**REZONING, PUD &
SUBDIVISION STAFF REPORT**

Date: November 2, 2006

DEVELOPMENT NAME Resubdivision of a Portion of Block 9, Pinehurst

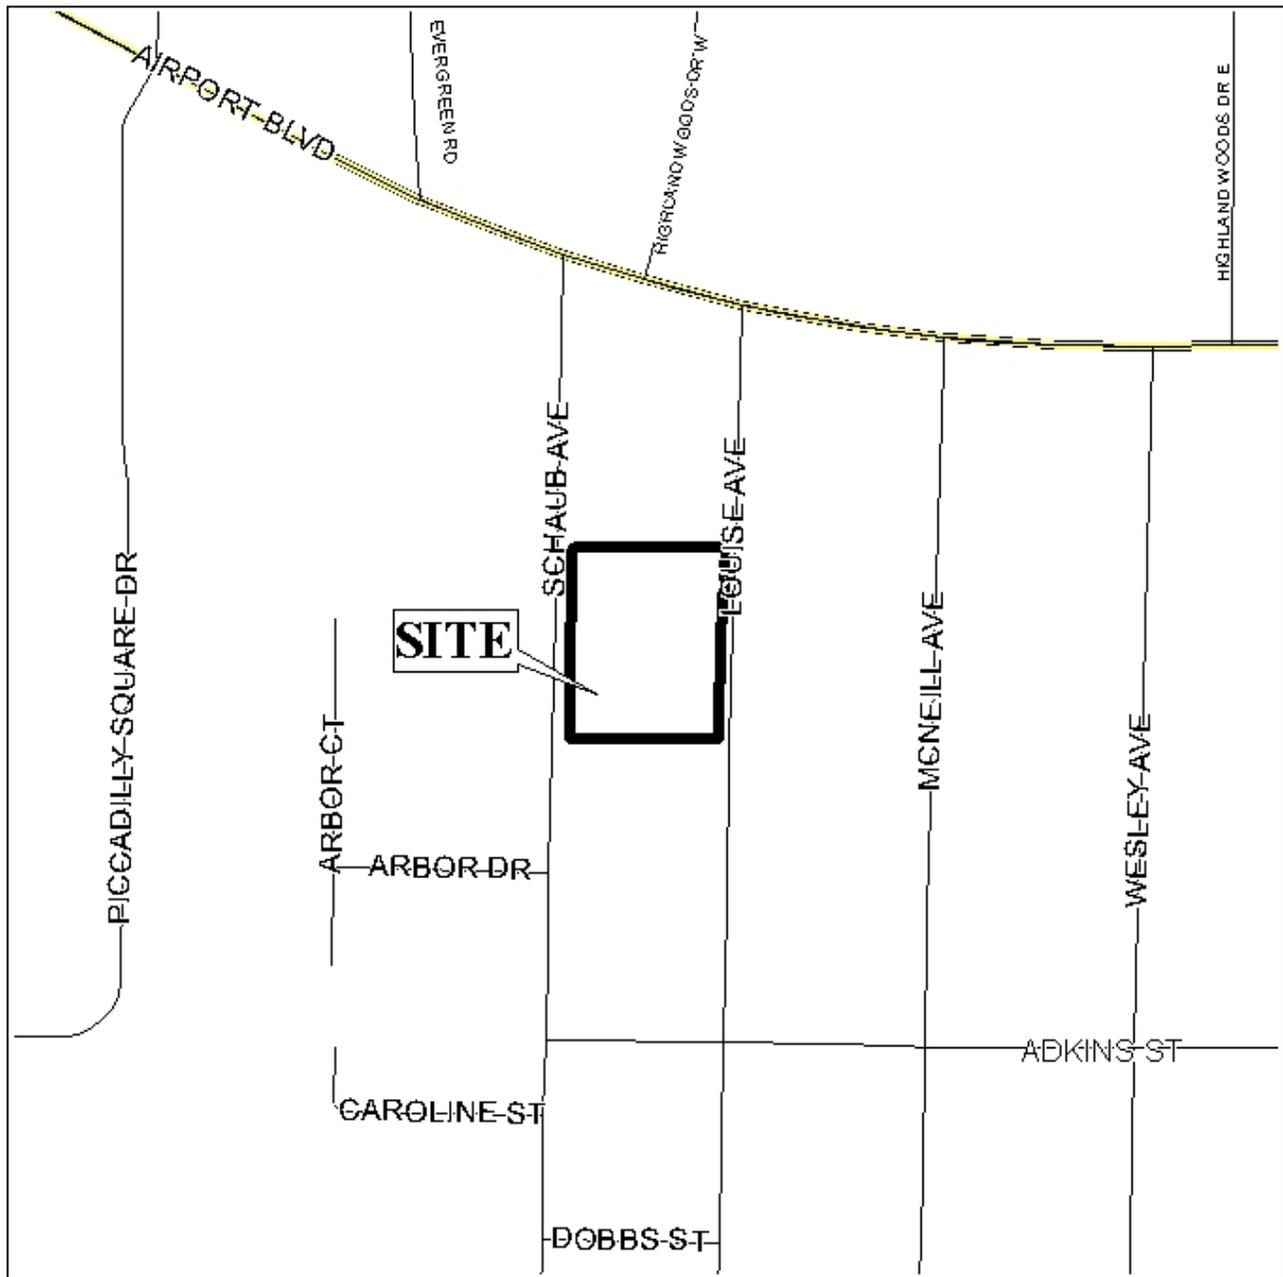
Louise Avenue has an existing right-of-way of 40'. The minimum right-of-way required would be 50' for curb and gutter and 60' for non curb and gutter construction. The plat indicates dedication to provide 25' from centerline.

There are several issues that relate to the proposed development that must be considered. As proposed the average lot will be 43.12' x 122.42', approximately 5,280 sq.ft., which is considerably less than required for R-1, Single-Family Residential density and less than required by the subdivision regulations. While the subdivision regulations allow for reduced lot sizes for innovative subdivisions, such as a zero lot line or patio home development, generally those lots are at least 6,000 sq.ft. each, unless compensating open space is provided.

The plat indicates that the unopened right-of-way for Howard Street is to be vacated. If vacated after approval and recording of the final plat, Lots 8 and 9 will be increased to 68' in width and will provide a 25' sideyard setback along the adjacent residential properties. If the plat were to be reconfigured, incorporating the proposed vacated right-of-way and reducing the development to 14 lots, the lot sizes would then be 52.13' x 122.42', 6380 sq.ft., which would be comparable with lots in the surrounding area, and would be four more lots than the existing configuration allows.

Comments from the City Engineering Department indicate that on site detention will be required. The plat submitted does not reflect any detention facilities, nor does it allow area for any to be provided.

Rezoning: Based on the preceding, the application is recommended for holdover until the December 7 meeting to allow the applicant to submit revised plans incorporating the proposed vacated right-of-way and reducing the development to 14 lots
